# List of Commenters

**SUBJECT:** Bicycle Master Plan – MCDOT Public Hearing Comments

**REVIEW OF MONTGOMERY COUNTY'S DRAFT BICYCLE MASTER PLAN**

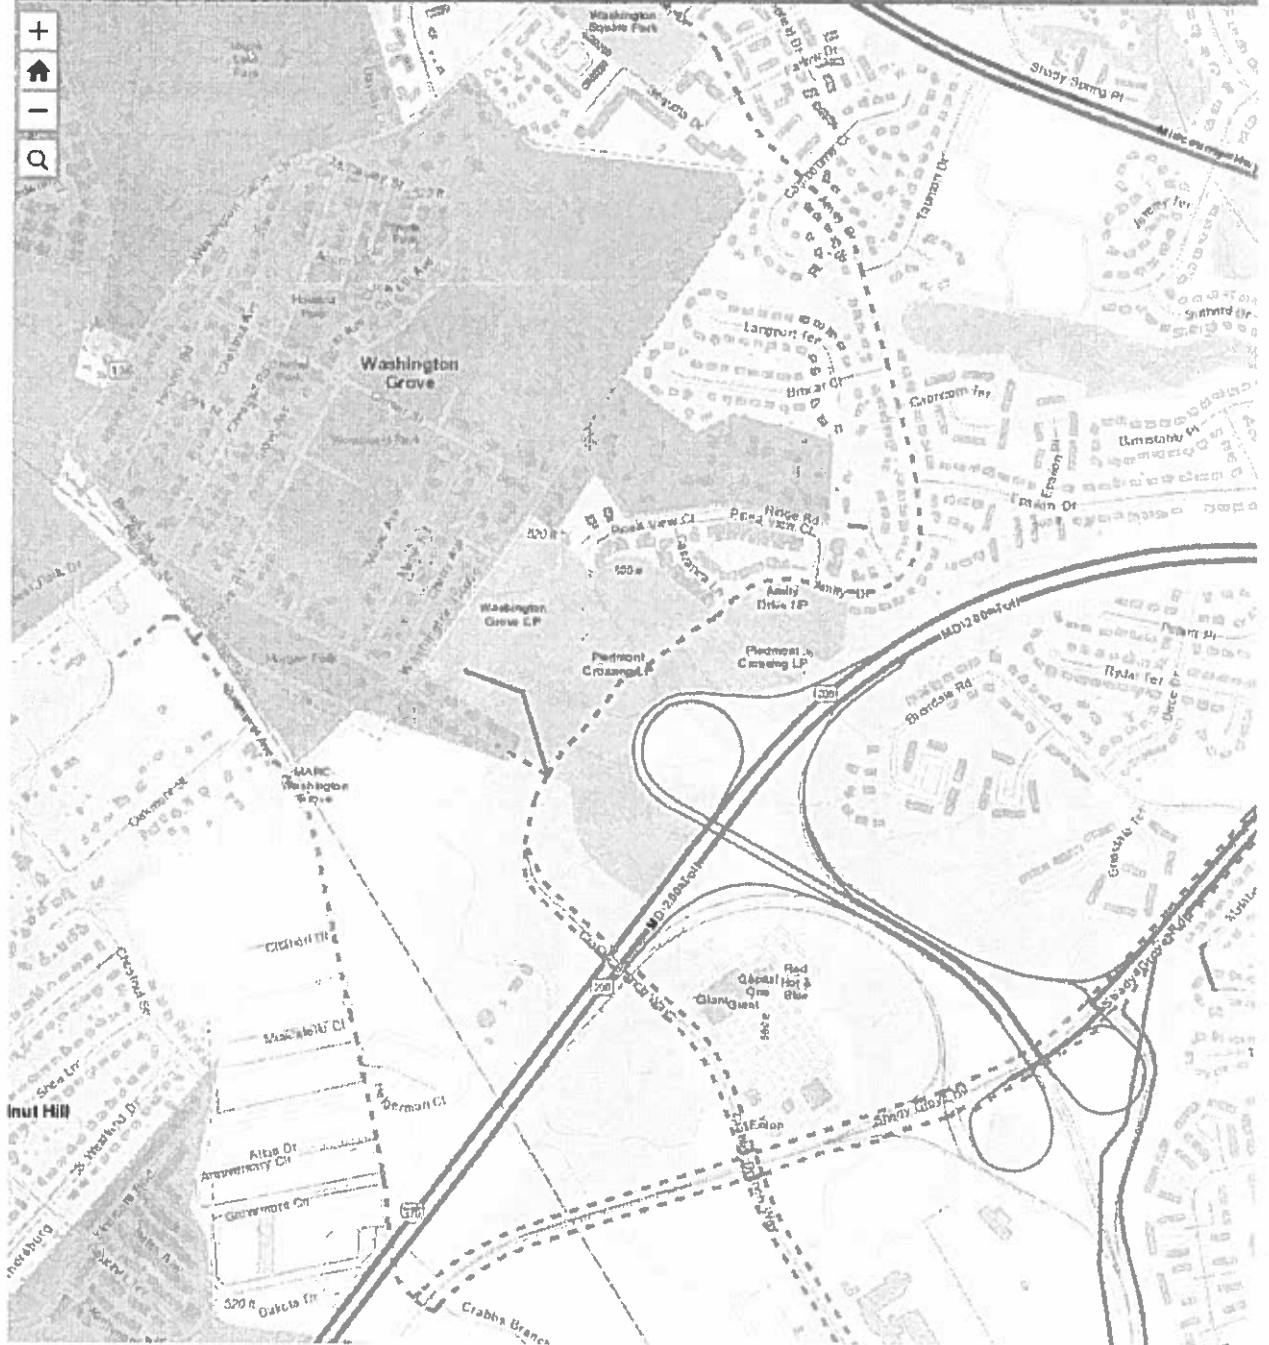
This Bikeways Master Plan recognizes two Bikeway segments originally proposed in the Shady Grove Master Plan. They are listed on p261 with Tier 3 priority in the Derwood Policy area of the Draft (named as the Piedmont Crossing LP Trail). *Tier 3 priority quite simply fails to recognize the importance of completing a safe a direct Bikeway and multi-use route - to the County, to Washington Grove, and also to the City of Gaithersburg.*

The Town Council and Mayor of Washington Grove urge you to assign Tier 2 priority for segments in the Plan that would complete Bikeway access from the Shady Grove Metro north to Washington Grove and Gaithersburg

**Figure 4. East County Bike Plan Neighborhood Bikeway Suggestions**

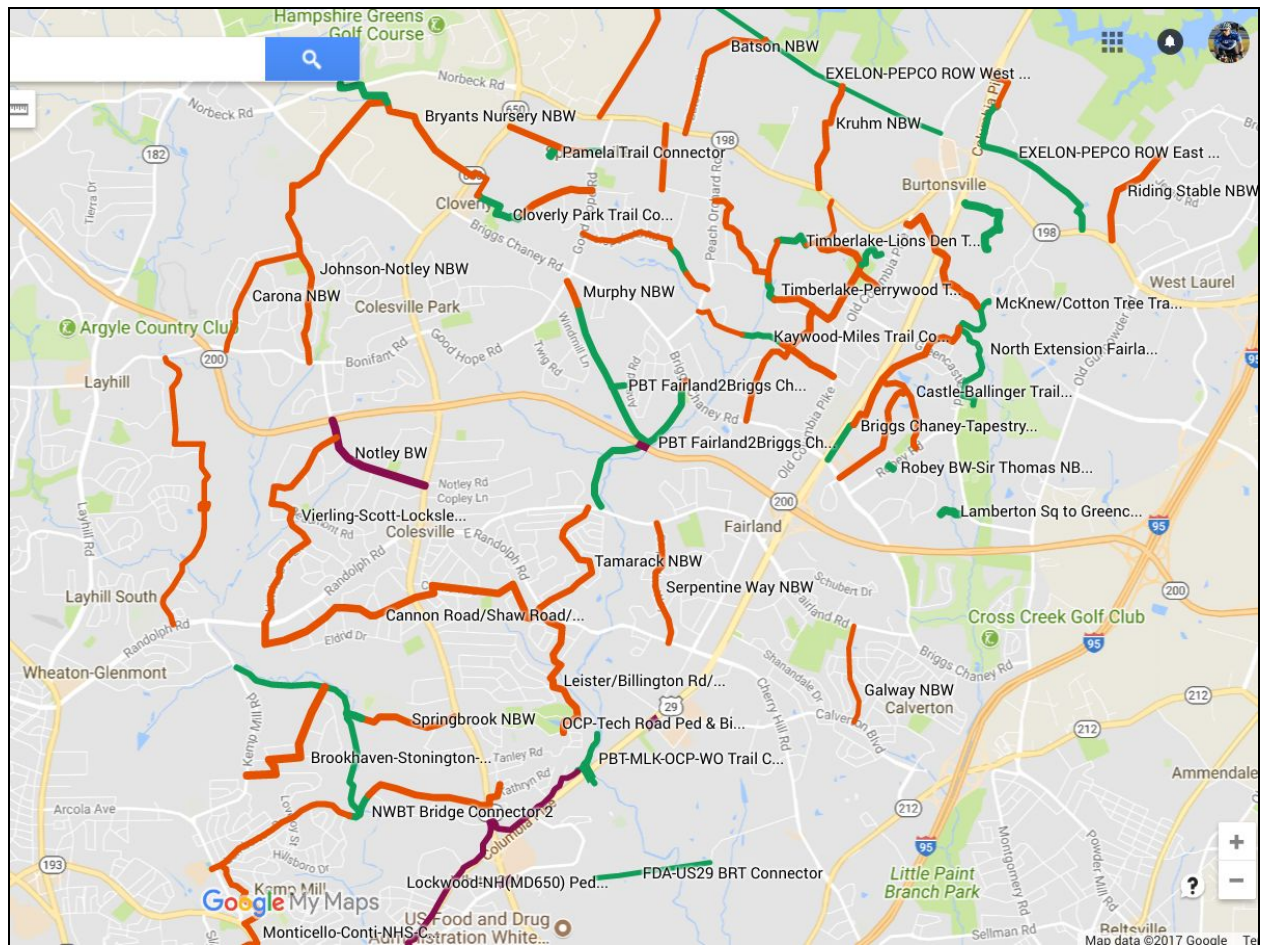
Figures 4. and 5. provide thumbnails of detailed graphical depictions of our recommended bicycle infrastructure to be included in the Montgomery County Bicycle Master Plan. We encourage your team to review the detailed recommendations that we have catalogued in the following media:

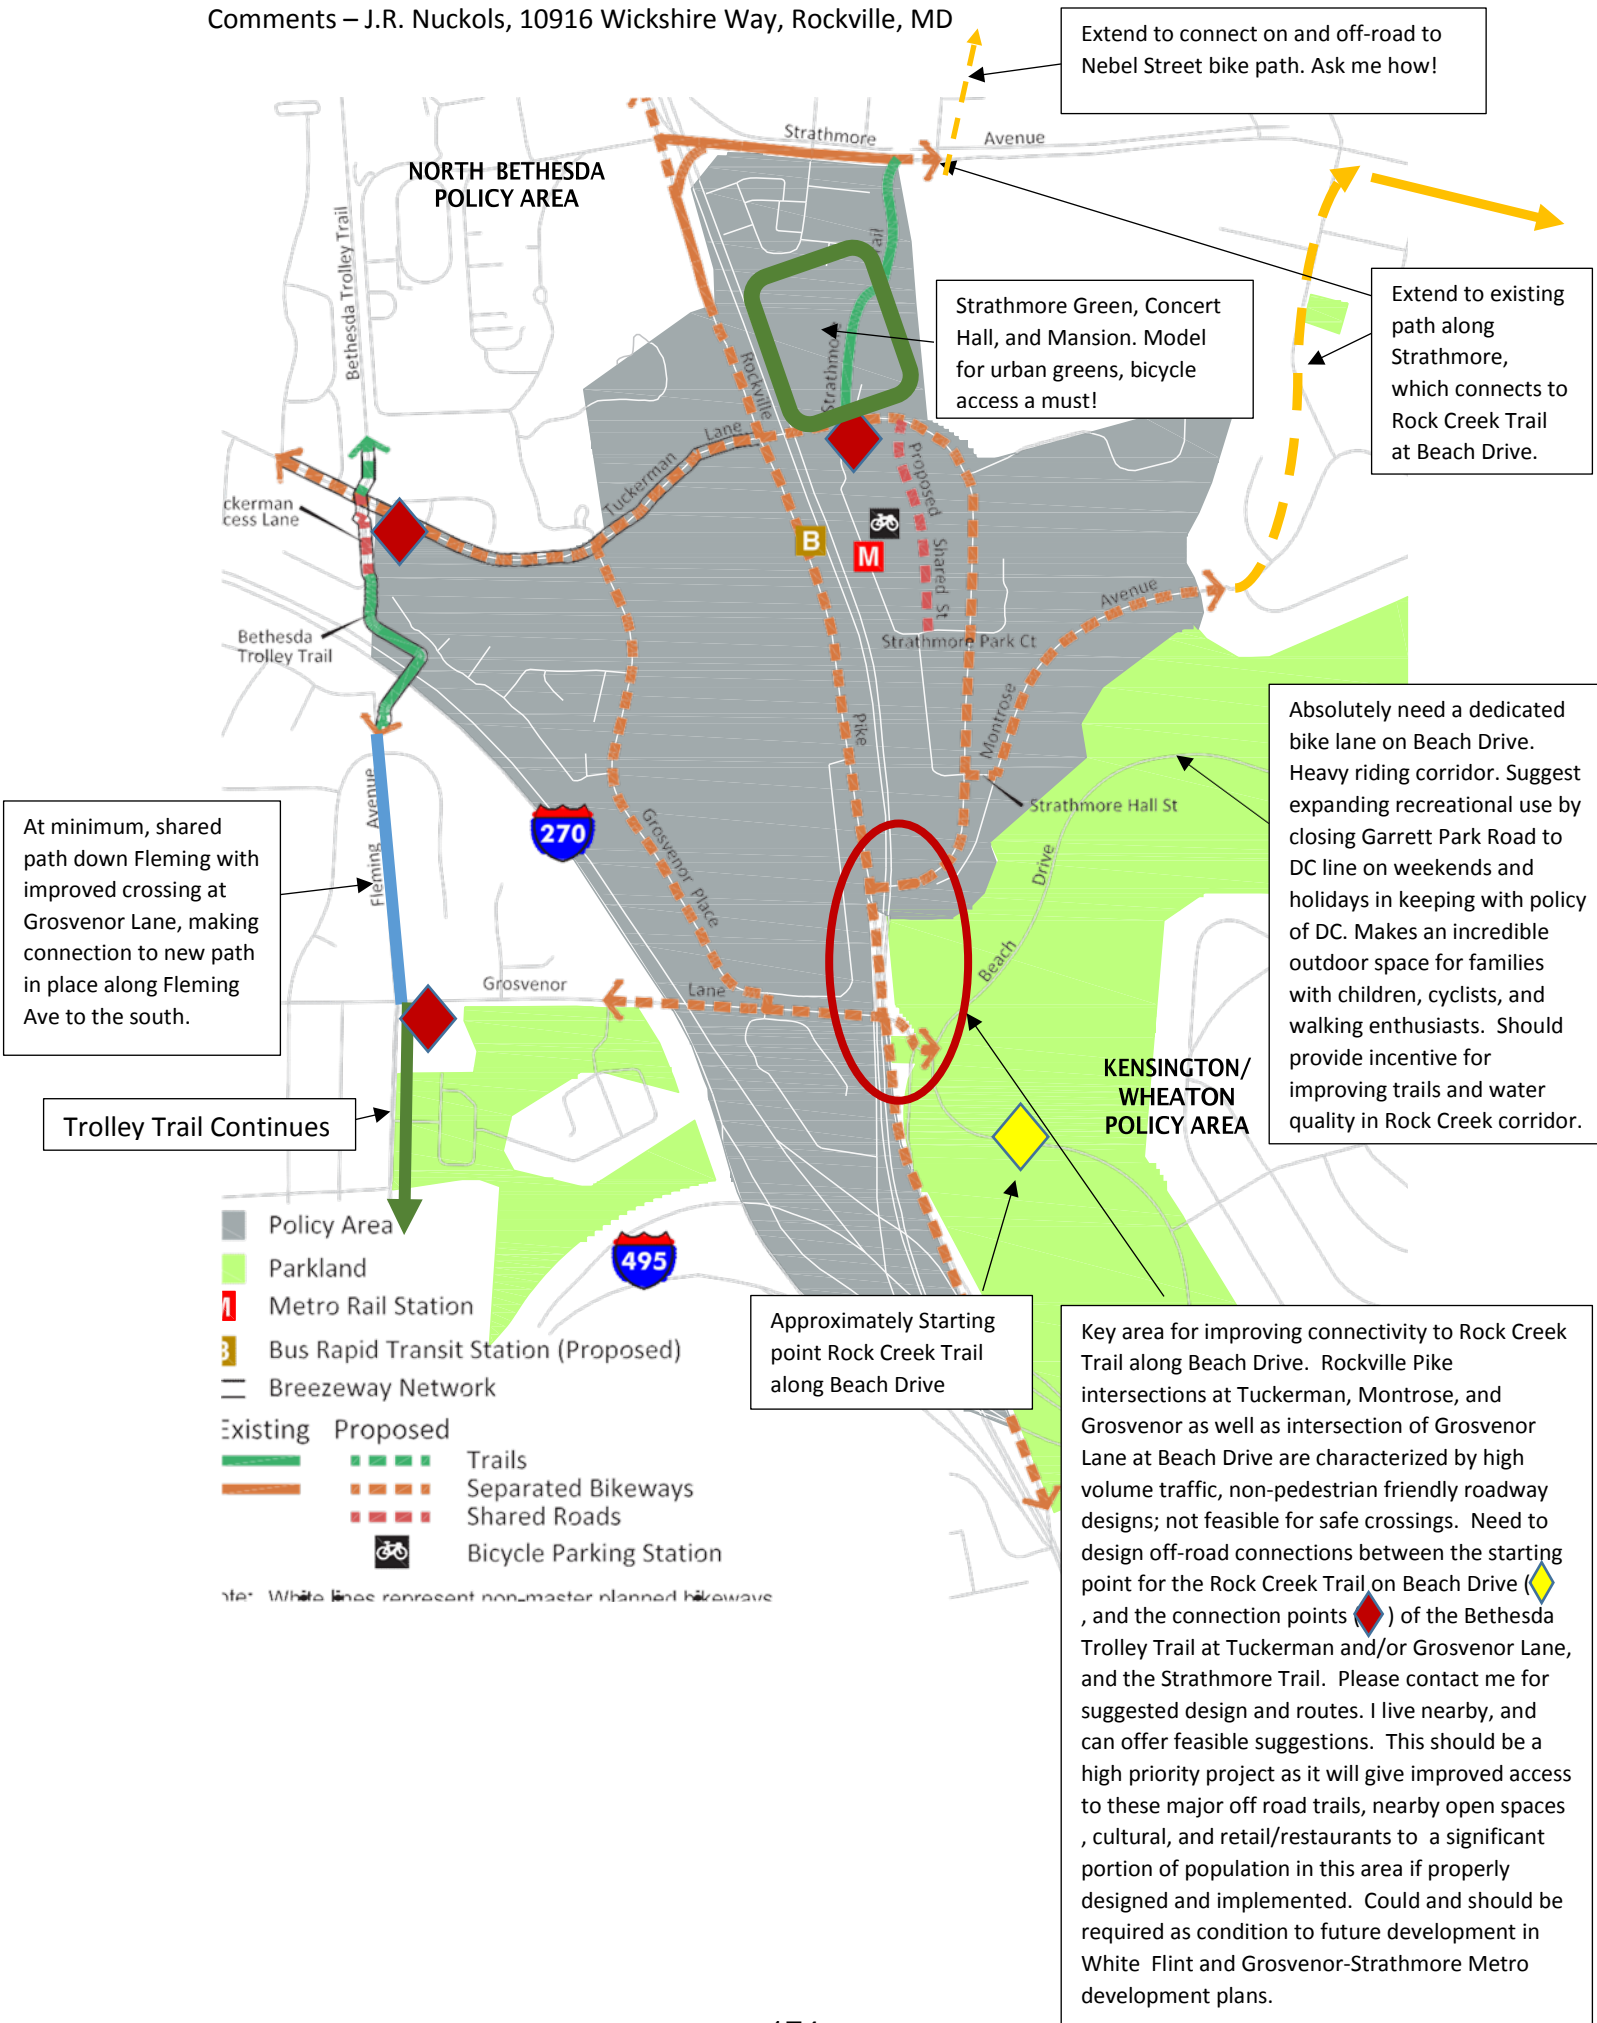
Attached please find my specific recommendations for improving the plan towards the above goals in the Grosvenor Planning Area (P. 290) in the report.

I live in this area, and use my bicycle for commuting, shopping, and recreation. I know it well, and would be happy to meet with planning or engineering personnel to discuss and demonstrate how the improvements I suggest could be designed and constructed. I hold degrees in civil engineering, and have a good understanding of infrastructure planning.

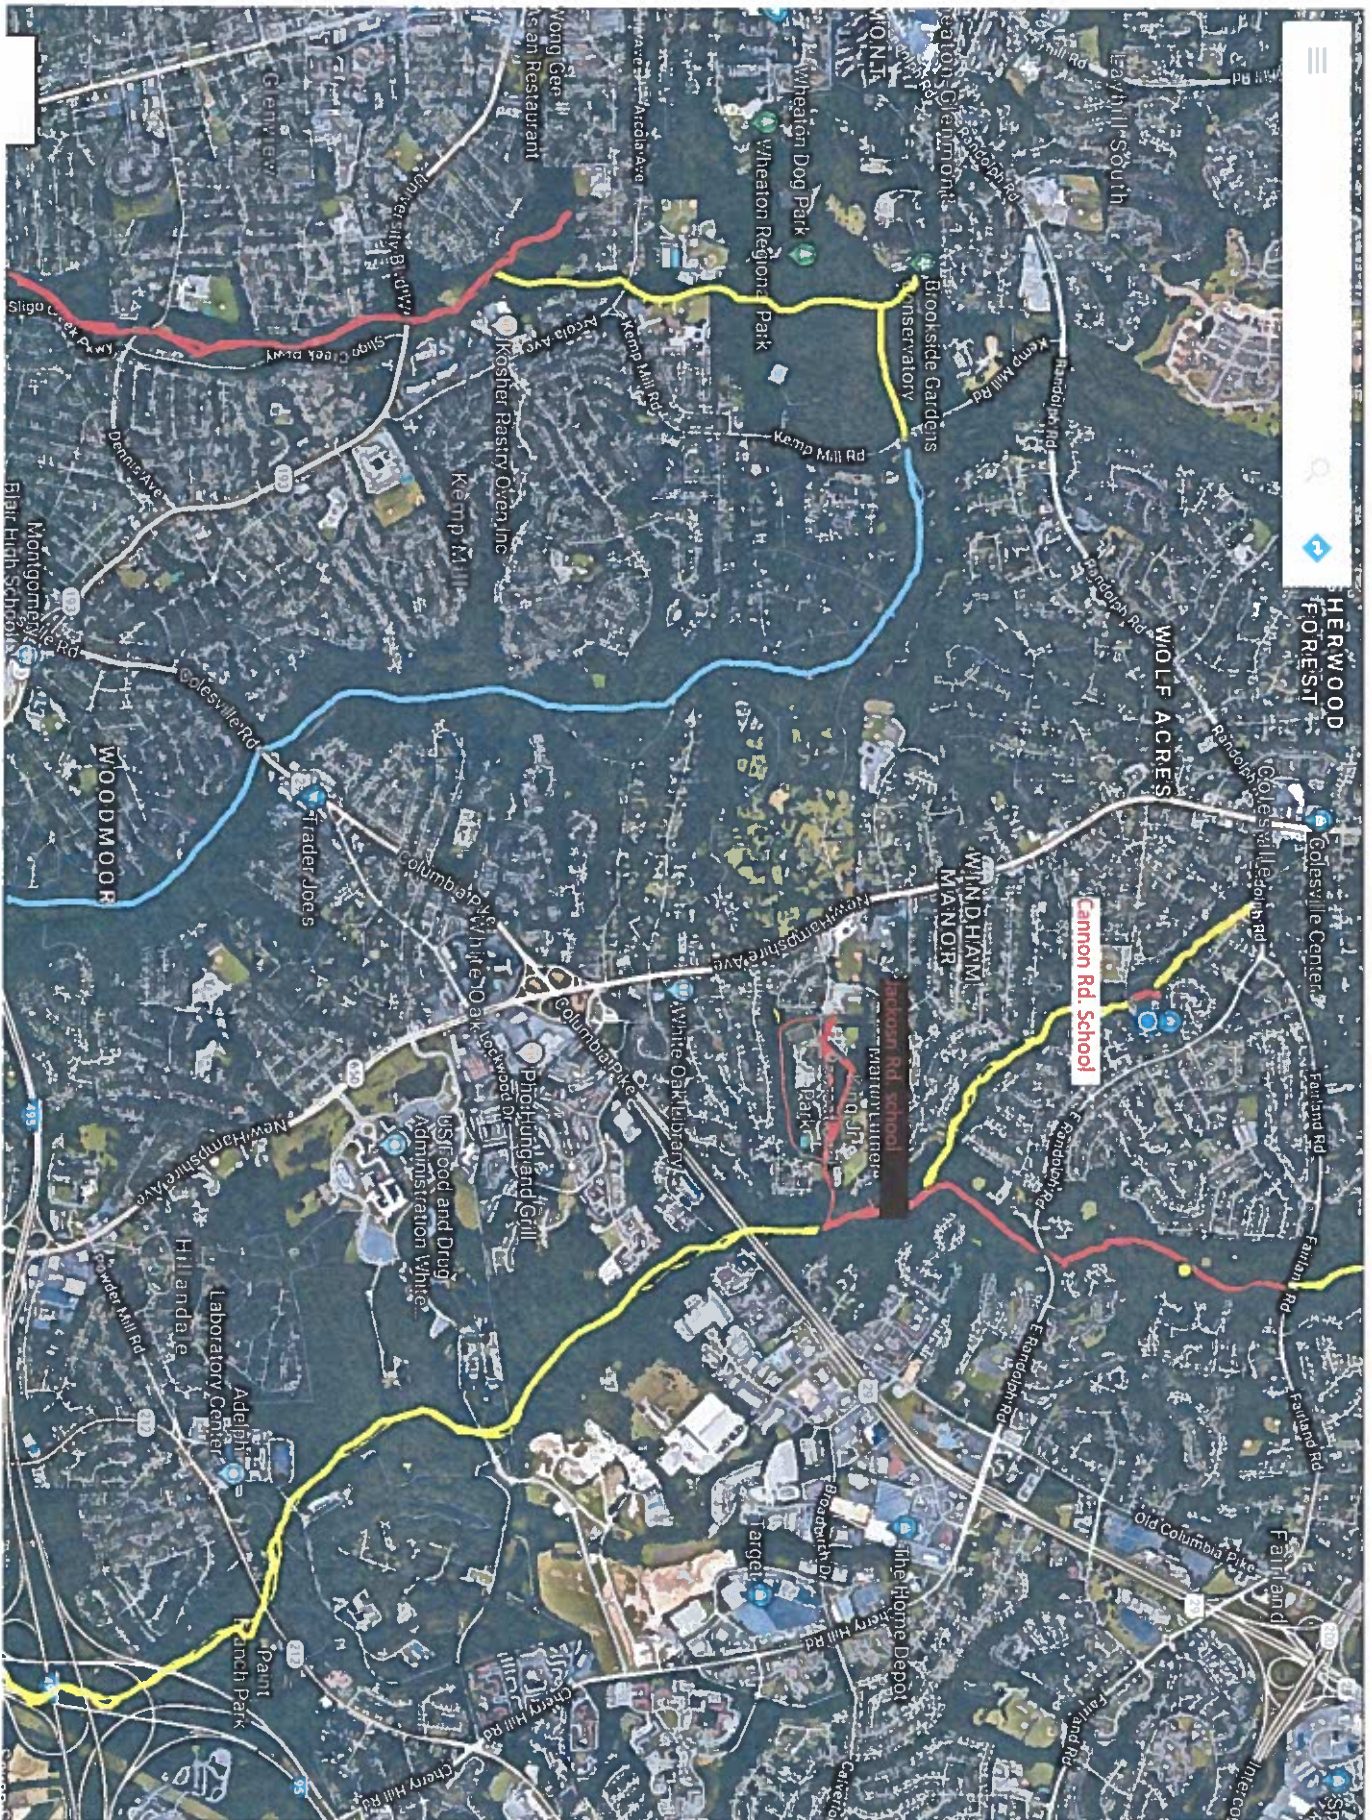
The paths would serve Cannon Road School and Jackson Road school (which would use existing road for short distance and paved path in Martin Luther King Park. The White Oak library could be reached using some local streets. This is not an extensive list, just what I could do in an hour.
